August 3, 1984

HOPE CREEK GENERATING STATION  
DOCKET NO. 50-354  
DRAFT SAFETY EVALUATION REPORT  
OPEN ITEM STATUS

In addition, enclosed for your review and approval (see Attachment 4) are the resolutions to the Draft SER open items, FSAR question responses and structural geotechnical audit item responses, listed in Attachment 3.

FIGURE A-13-19

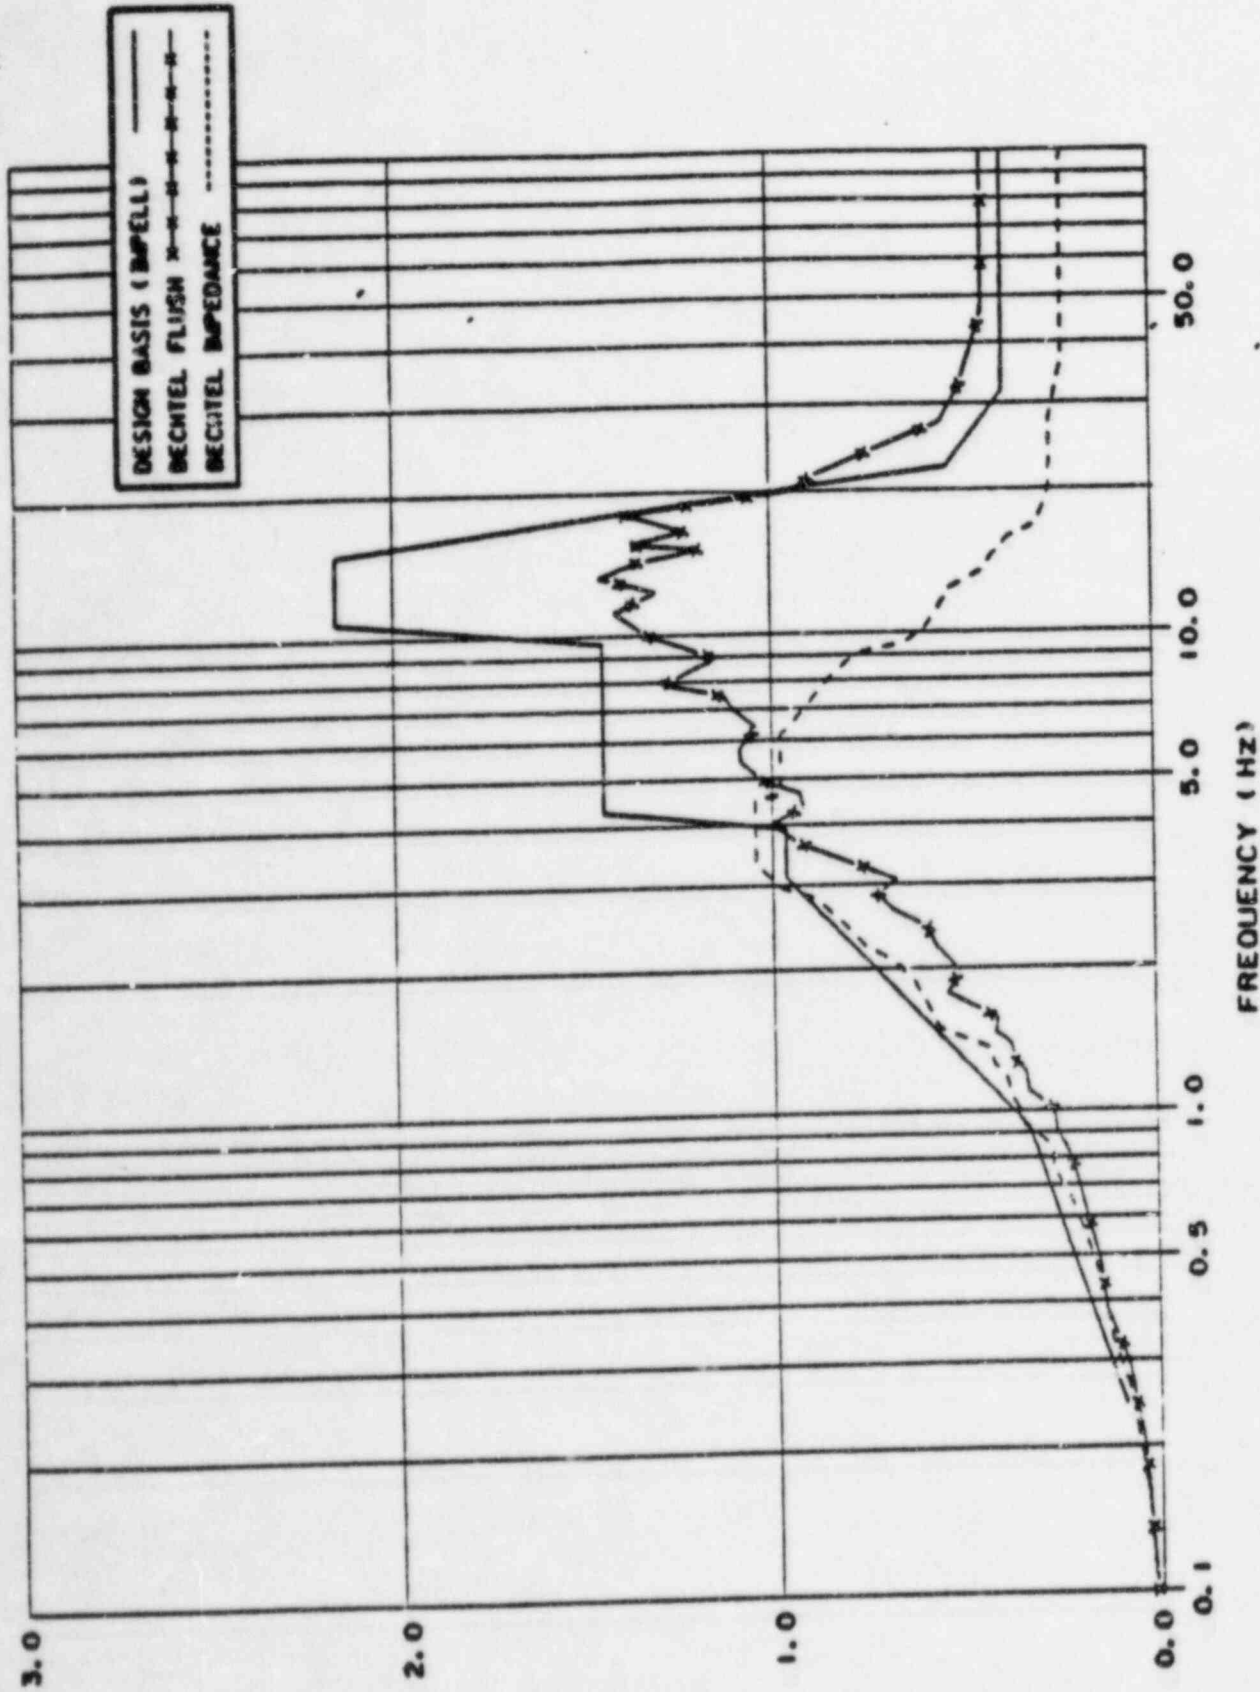
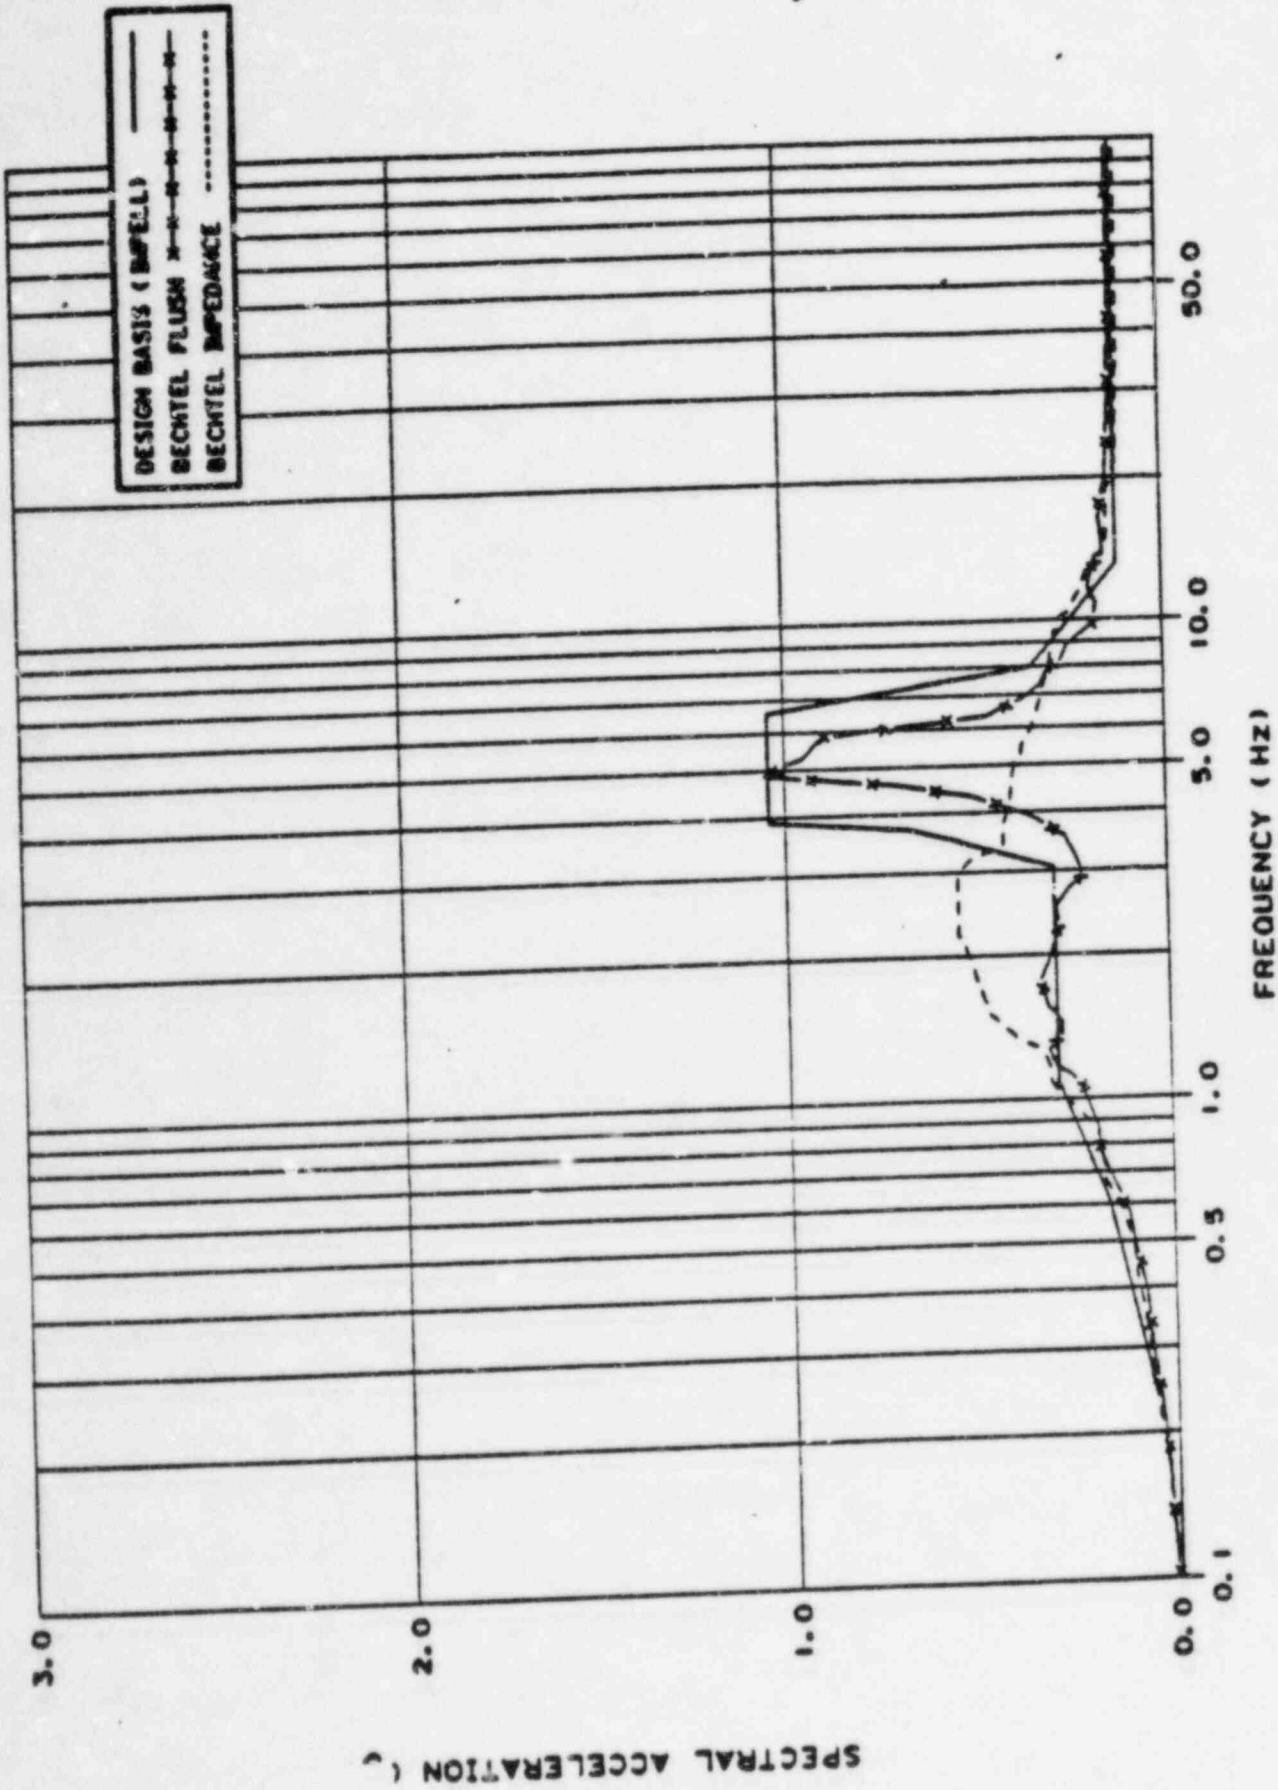
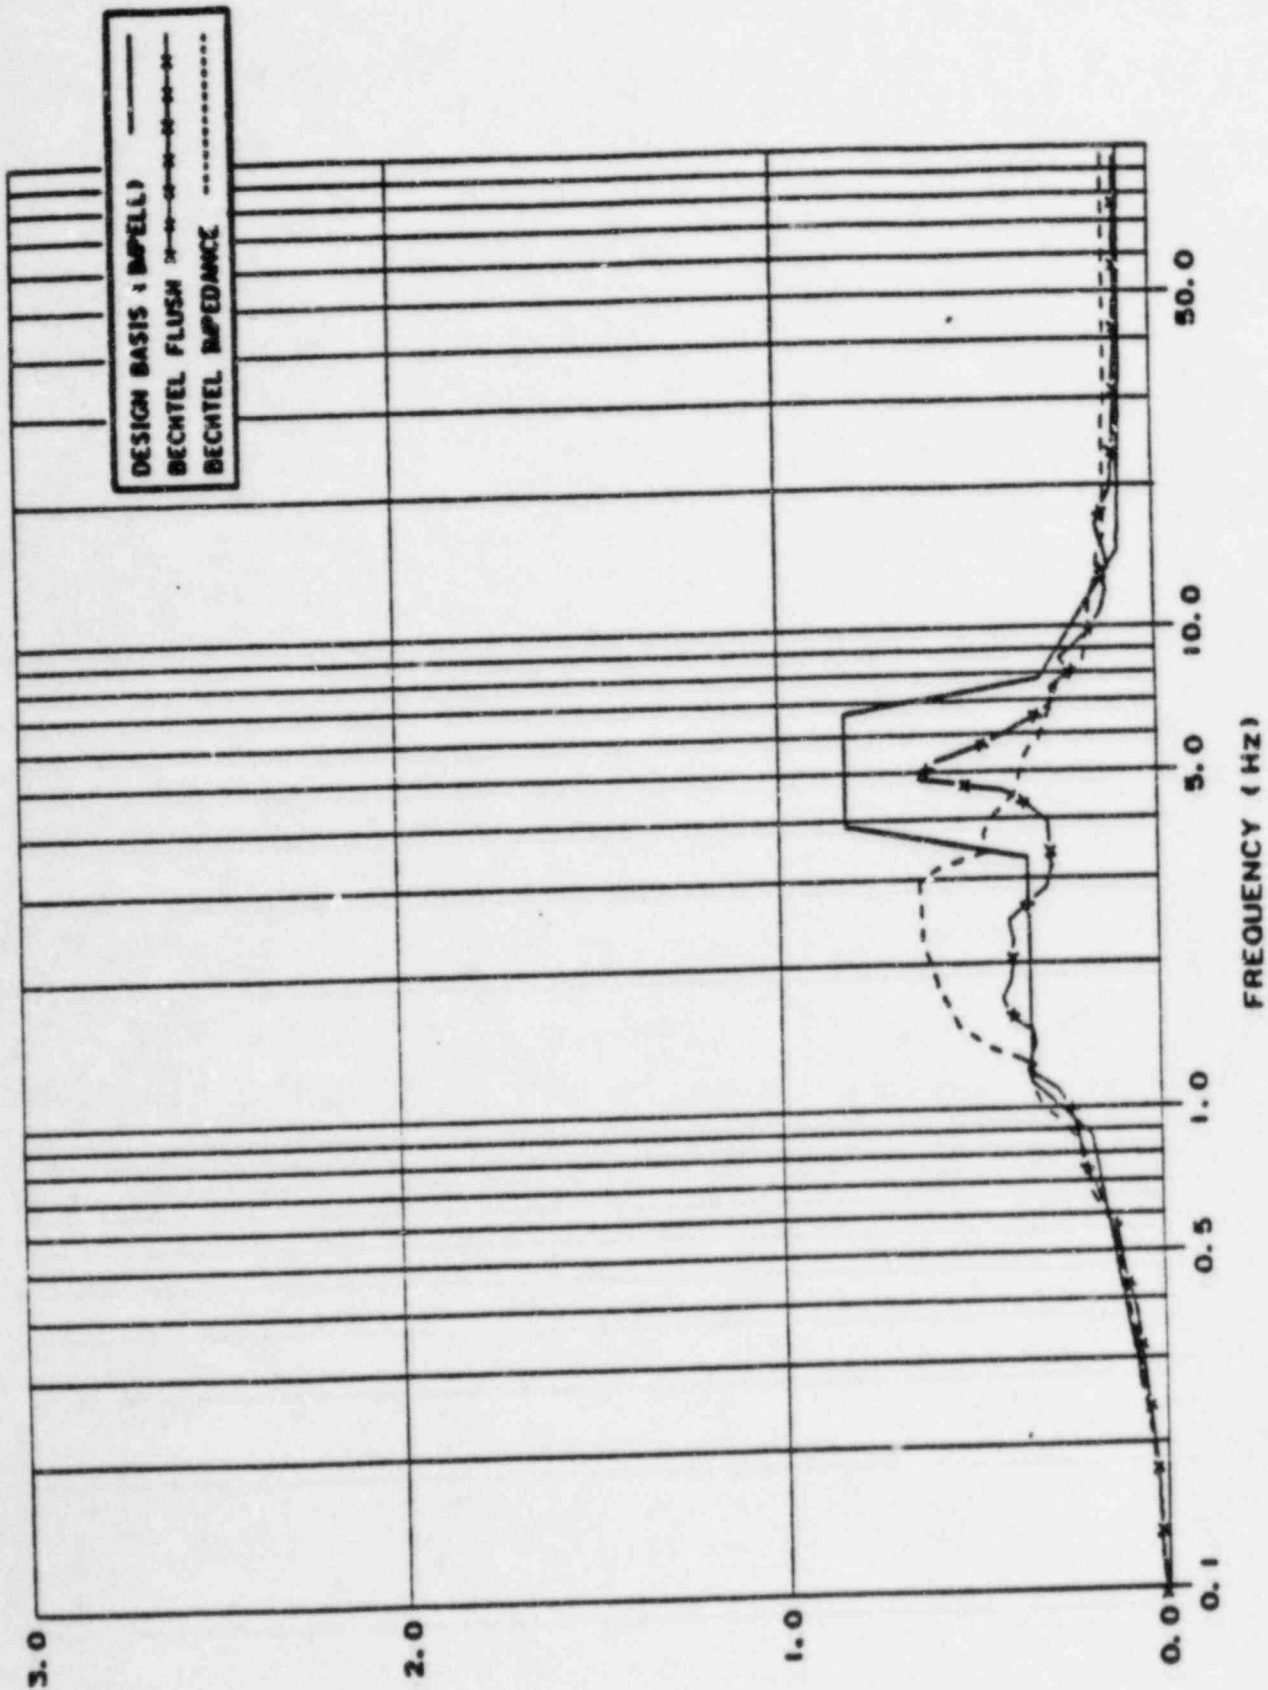
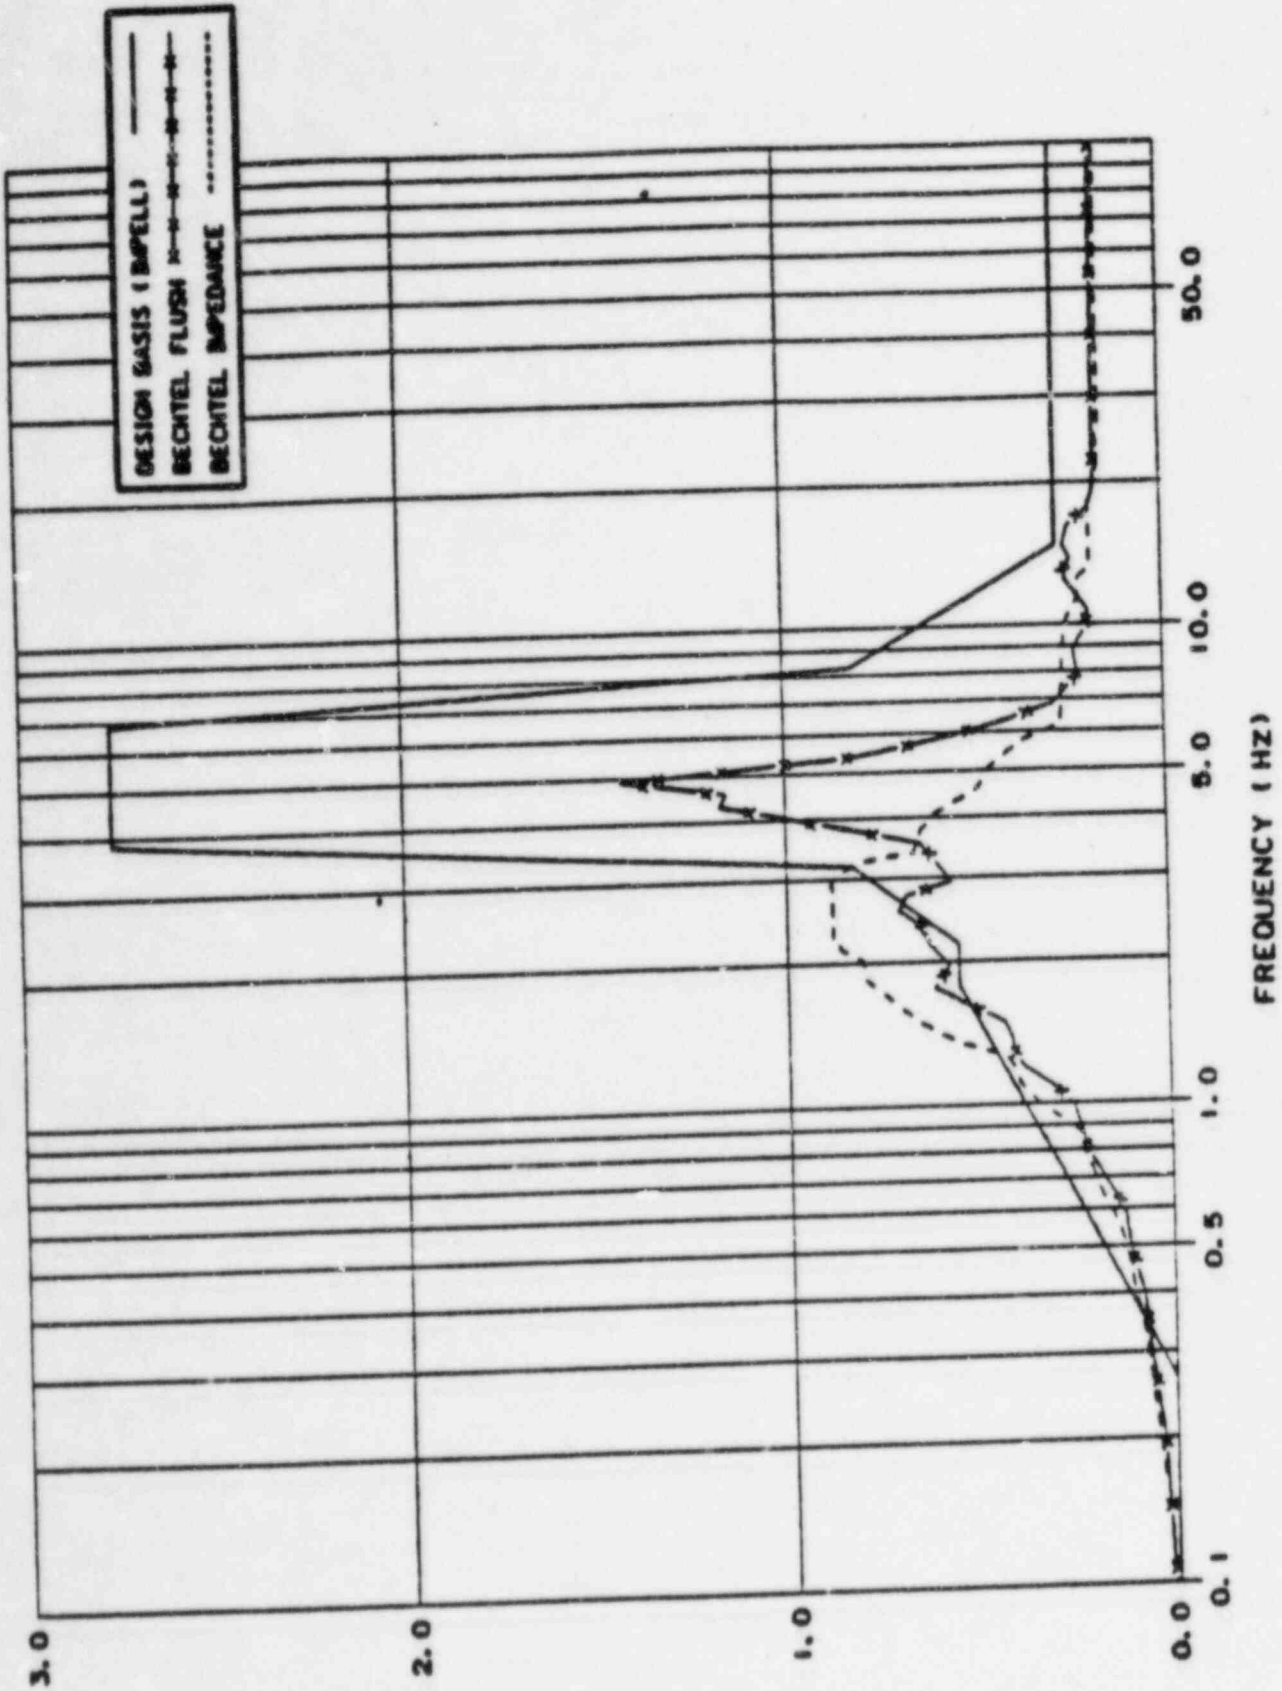
Question: Provide comparison of Bechtel Independent Verification Results with the Design Basis Results.

Figures A-13-2 to A-13-37 show the comparison of the response spectra (2% damping) obtained from the above three seismic soil-structure interaction analyses. Discussions of these comparisons are as follows:

Bechtel's independent soil-structure interaction analyses are performed using the computer code FLUSH. The results of independent finite element analyses are in reasonable agreement with those of the design basis analyses. As can be seen from Figures A-13-2 through A-13-37, the horizontal response spectra obtained from the independent finite element analyses are generally enveloped by those obtained from the design basis analyses except for the frequency range lower than 2 Hz. The vertical response spectra showed some exceedances at the frequency range of 18 Hz. These exceedances are listed in Table A-13-1.

The peak spectral accelerations obtained from the impedance approach analyses are generally lower than those obtained from the design basis analyses. However, these response spectra are not completely enveloped by those obtained from the design basis analysis, especially in the frequency range between 1.0 and 3.5 Hz. Also, there are some local exceedances in the higher frequency range, as shown in Figures A-13-2 through A-13-37.
